Department of Permitting and Inspections

MEMORANDUM

To: Development Review Board
From: Mary O'Neil, AICP, Principal Planner
Date: November 16, 2021
RE: ZP21-690 111 Colchester Avenue, Mod "B" building

Request: Approve the Mod B building as a permanent structure

WEST ELEVATION

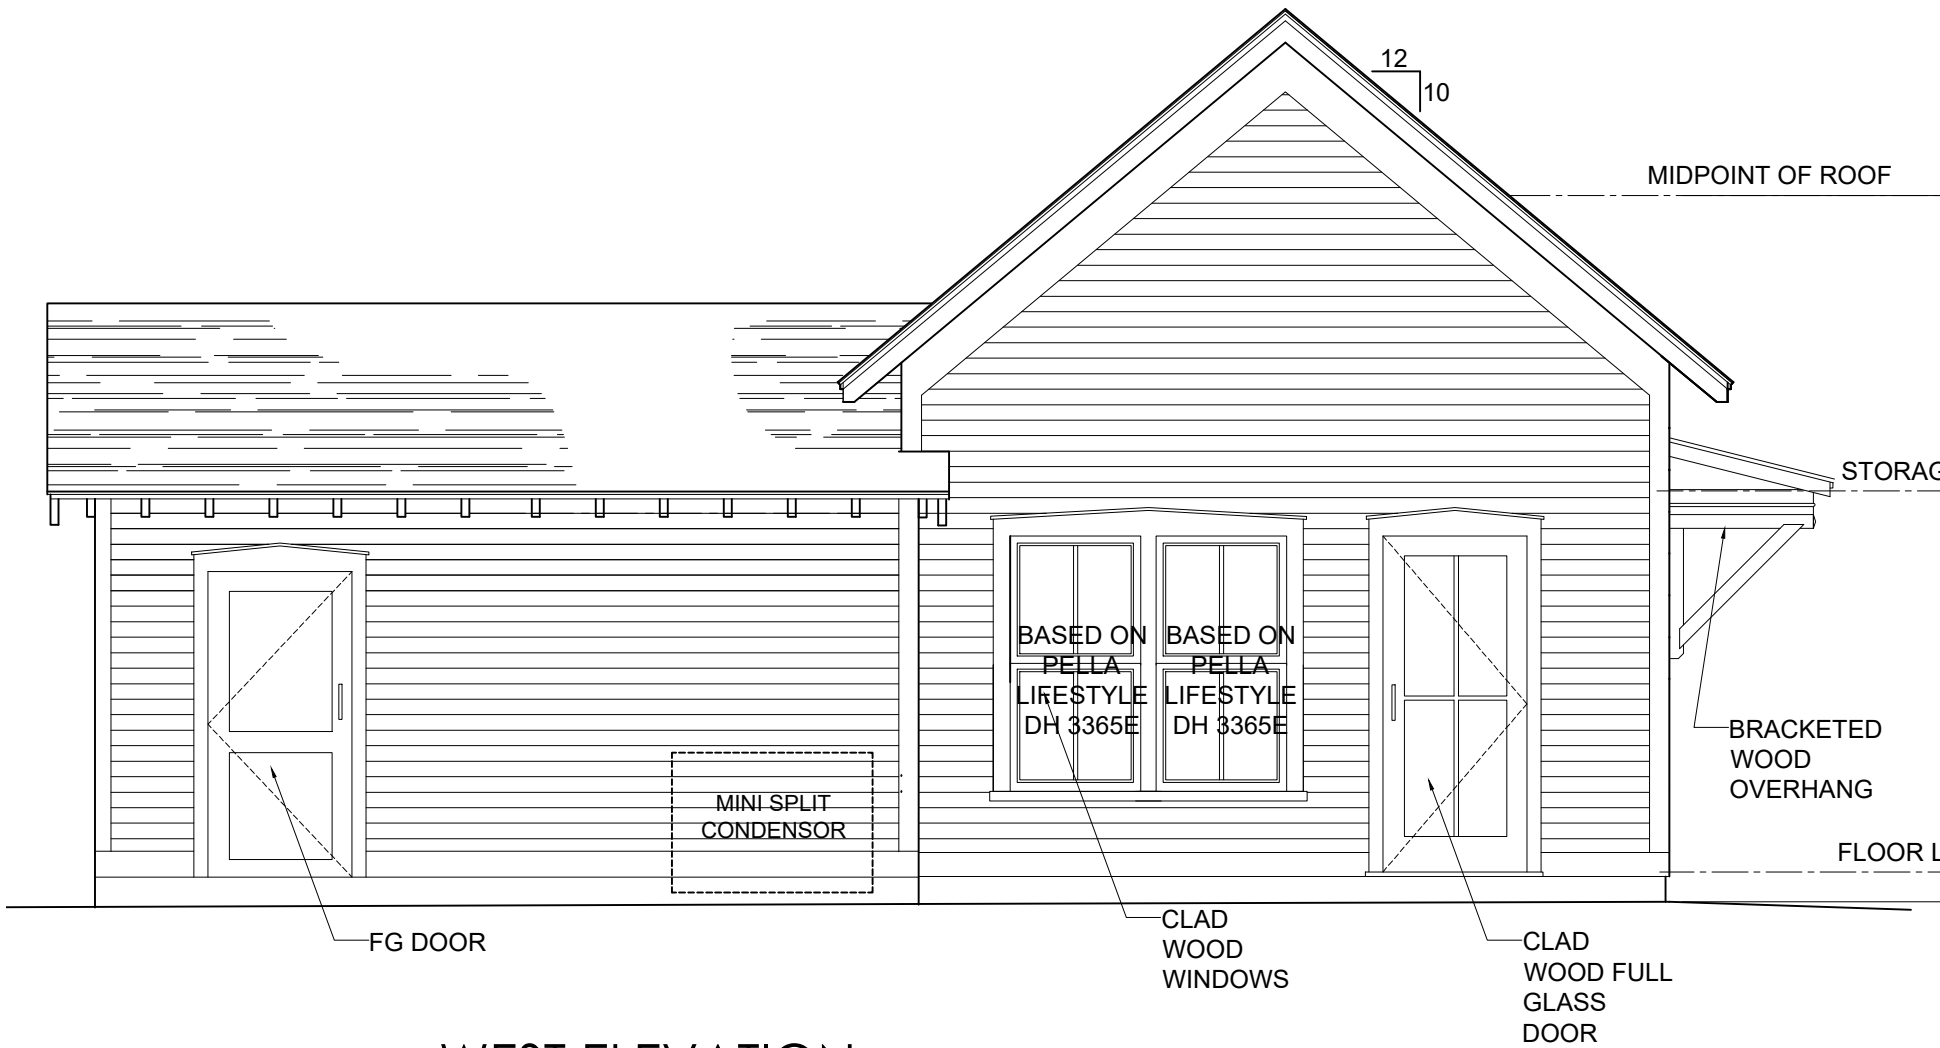
The condensing unit illustrated on the site plan and the west elevation falls within a required setback. The unit must be relocated, and potentially screened. **Affirmative finding as conditioned.**

3. The location of the mailbox for the ADU needs to be identified on elevations or site plan as appropriate.
4. The condensing unit illustrated on the site plan and the west elevation falls within a required setback. The unit must be relocated out of required setbacks, and potentially screened from view. **A revised site plan will be required to demonstrate compliance to setback.**

2 EXISTING - NORTH ELEVATION
SCALE: 1/8" = 1'-0"

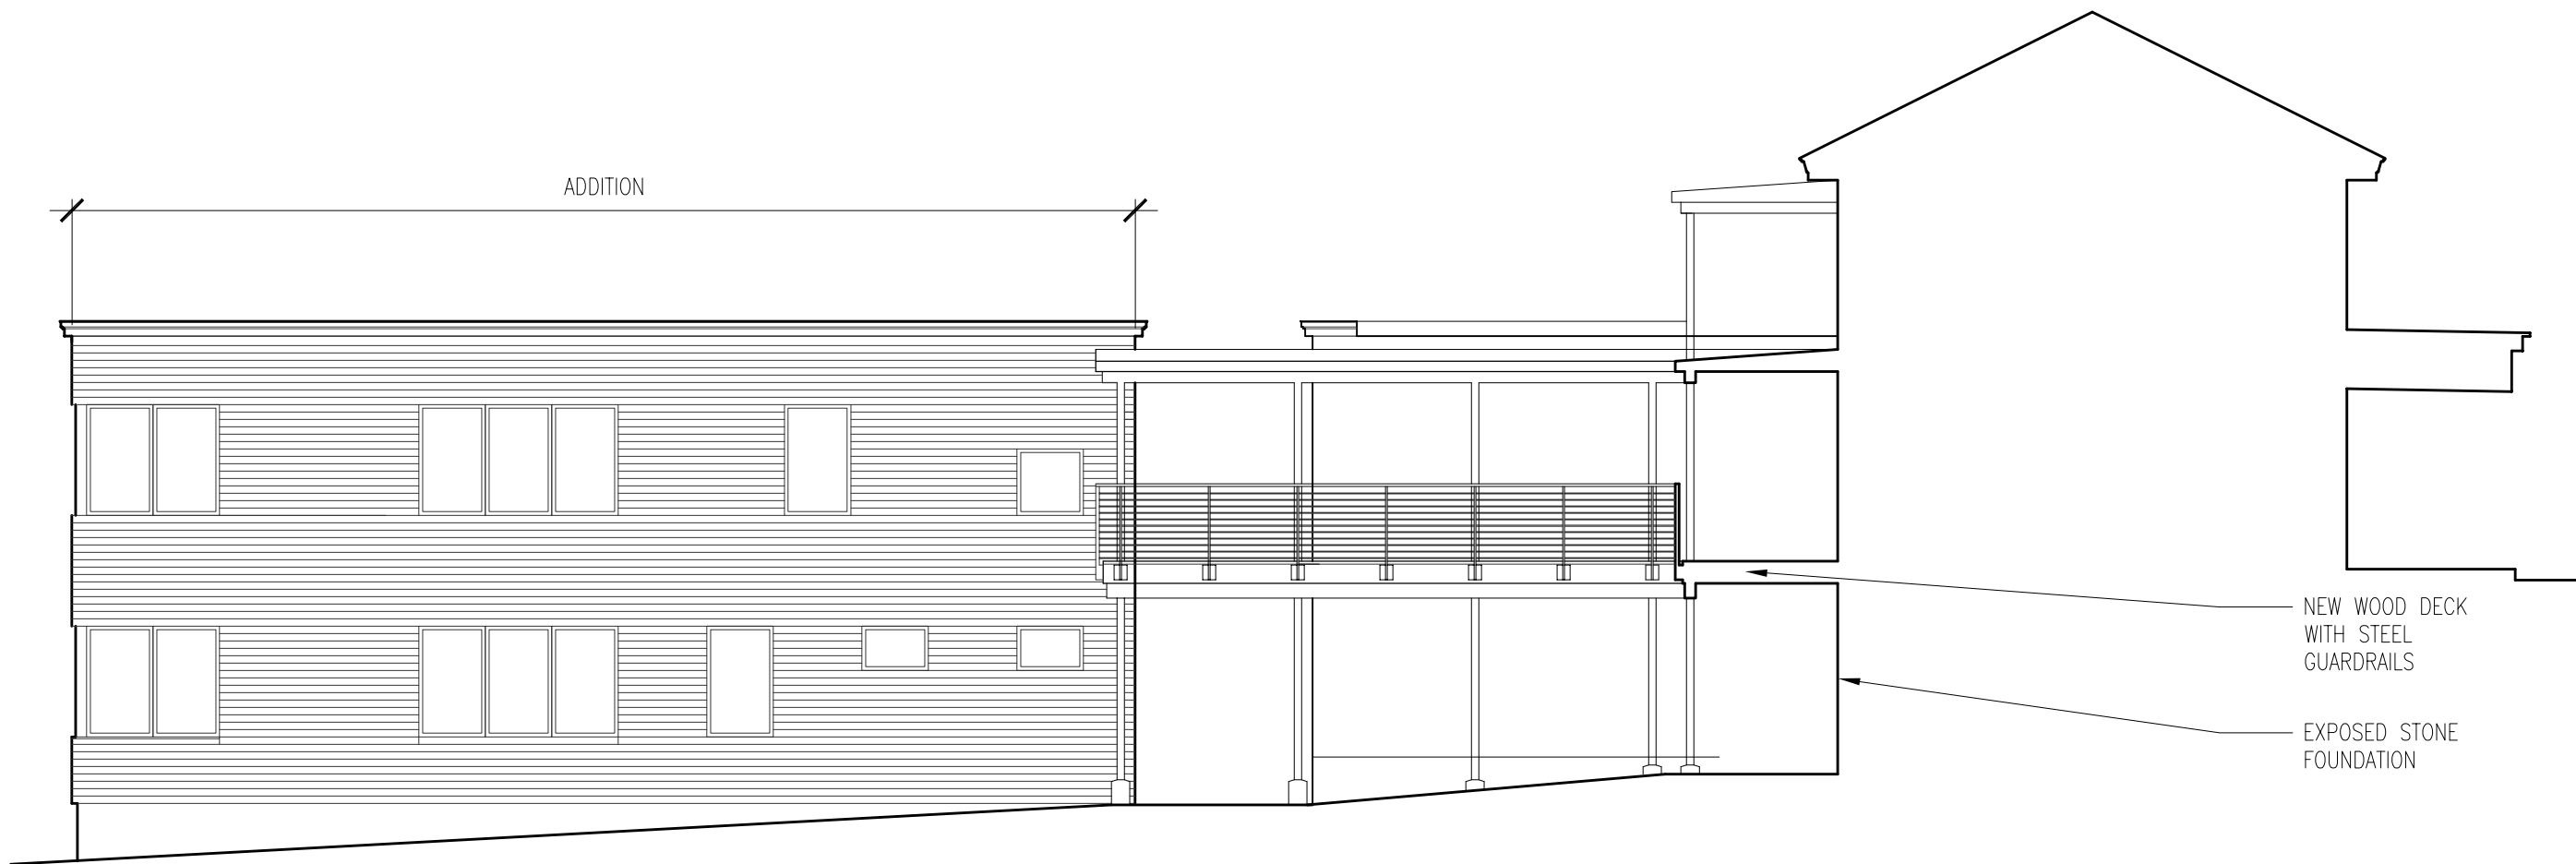
No elevation plans have been submitted for the detached multiunit structure. The addition, however, will have appropriately placed windows along each side and no large blank walls. While an east elevation plan was not submitted, it is assumed that there will be a door on the second level, and possibly on the first level. An east elevation will be needed with the zoning permit application submittal.

PROPOSED - SOUTH ELEVATION

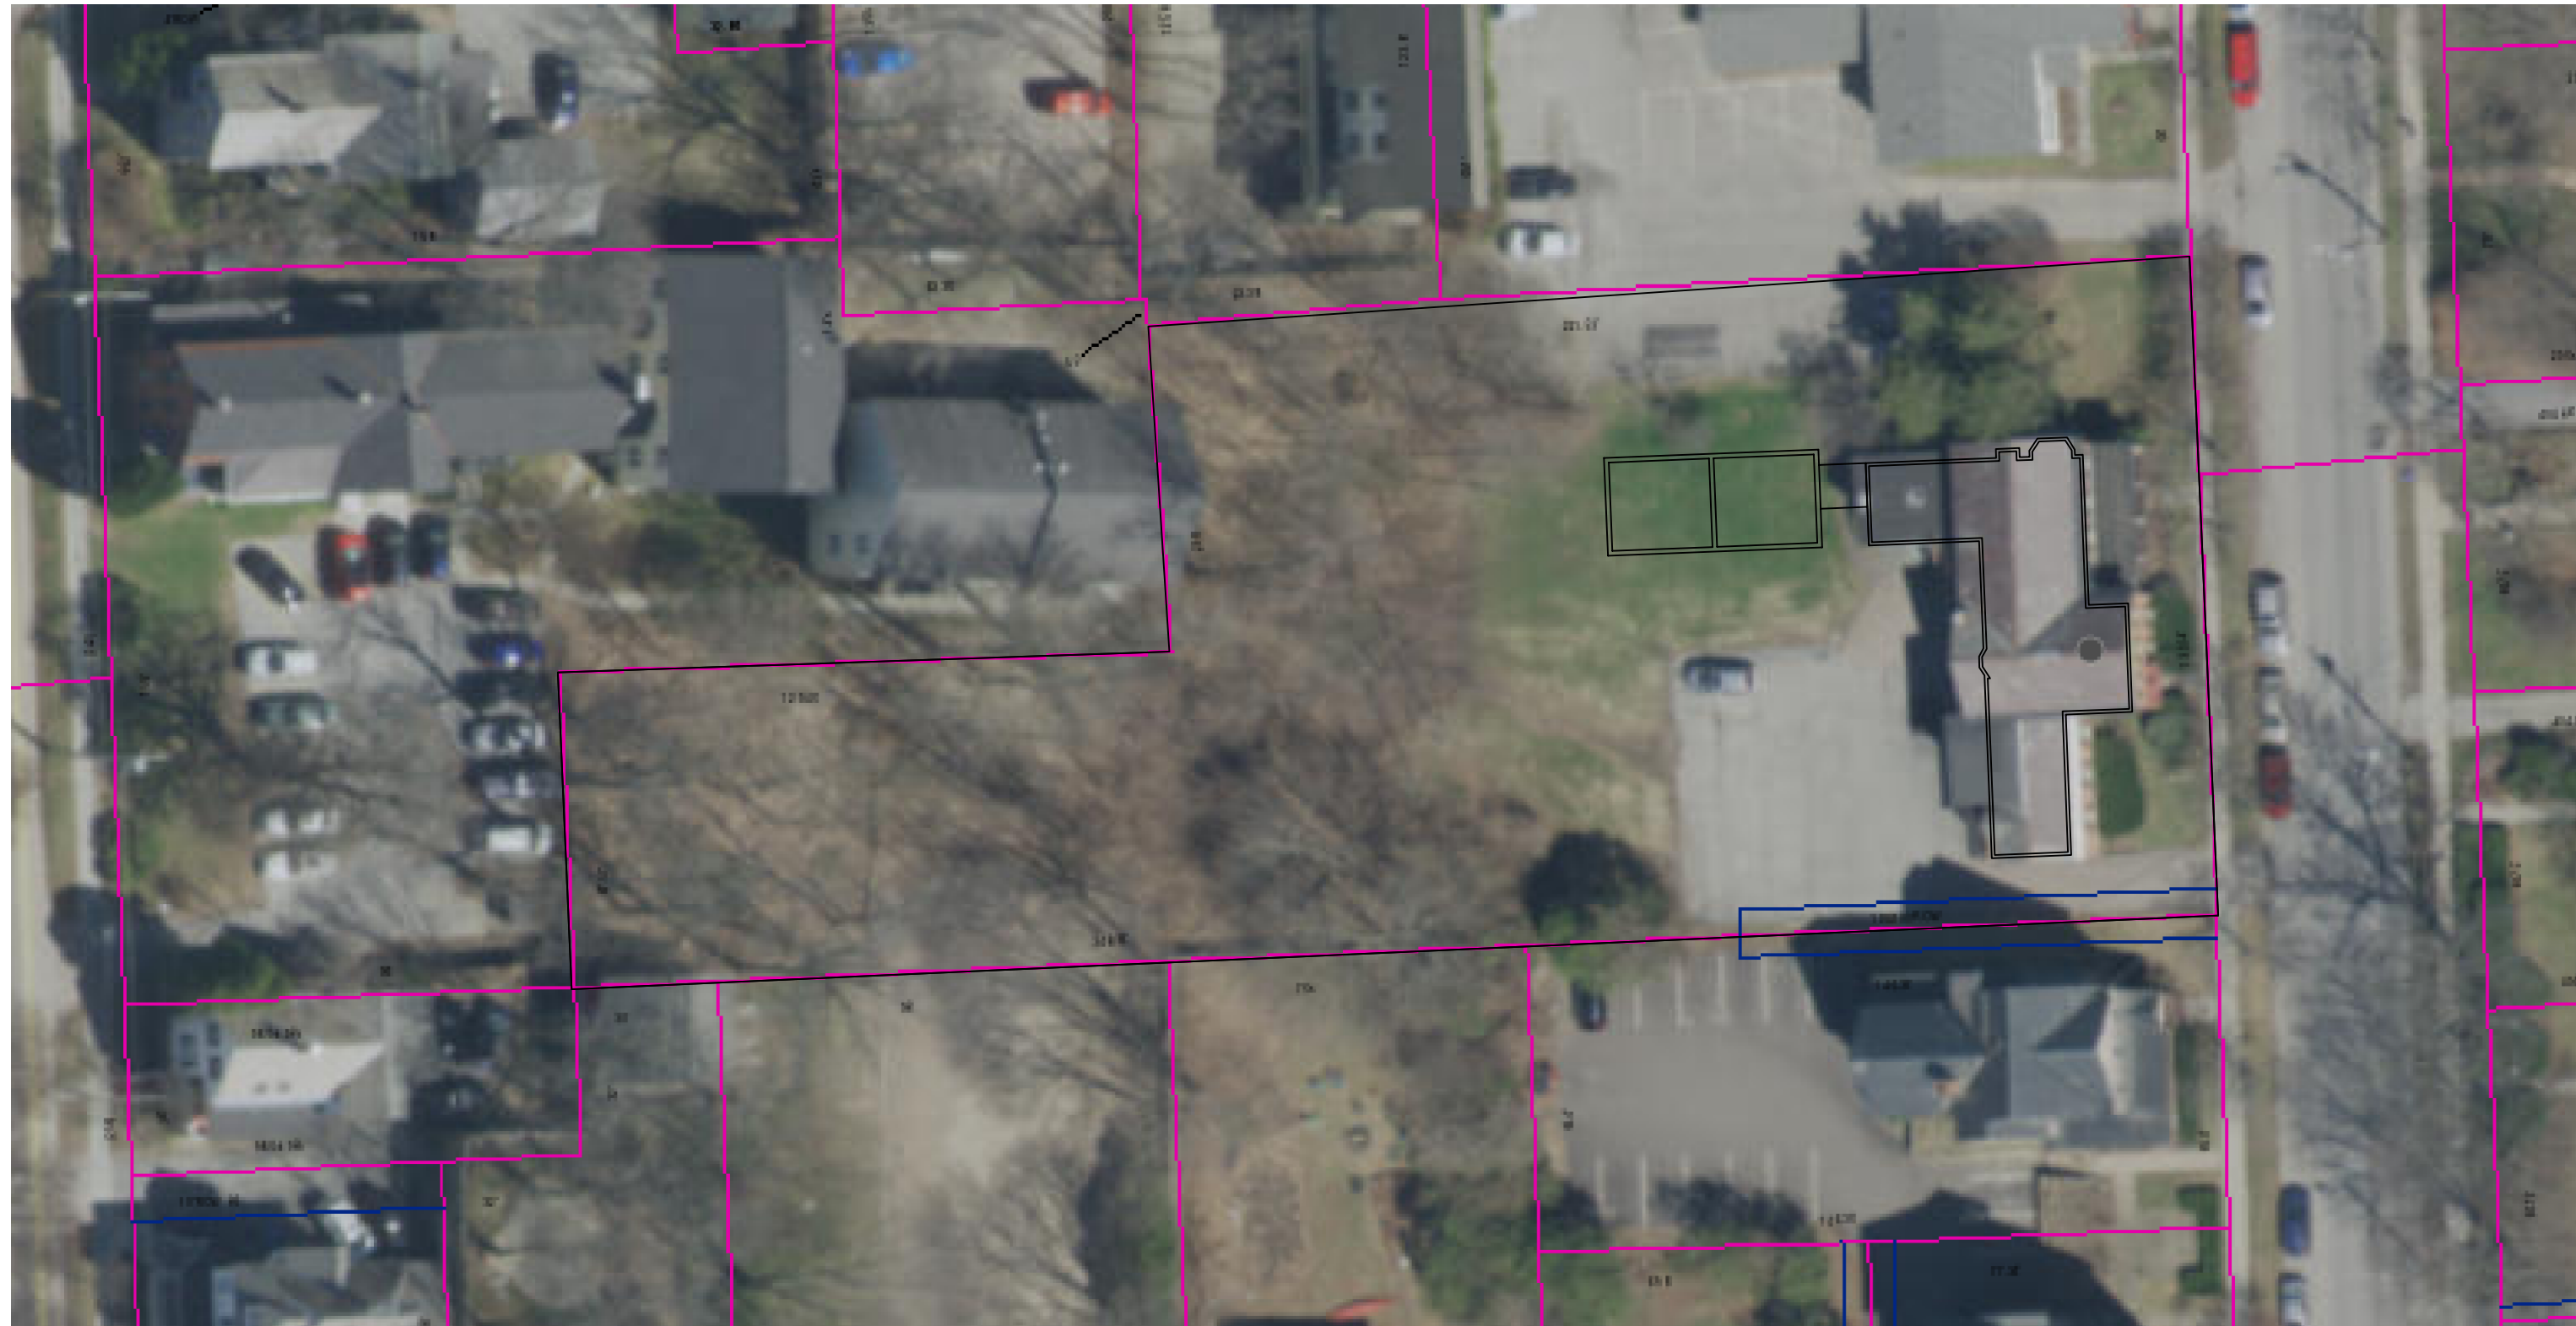
The plans indicate a covered second level entrance, and quite possibly at a first level entrance, where the addition joins with the existing structure. No east elevation has been provided to be sure. As noted above, the connection between the existing building and the addition will need to at least be enclosed so that the overall building is viewed as a single building.

No plans/elevations for the detached structure have been submitted. The elevation plans for the addition show wood clapboard siding, a concrete foundation, and a new wood deck with steel guardrails. New construction usually warrants a variety of acceptable materials. The addition and detached structure should offer no exception to that allowance. The applicant will need to provide spec sheets for all windows, doors, roofing materials with a future zoning permit application.
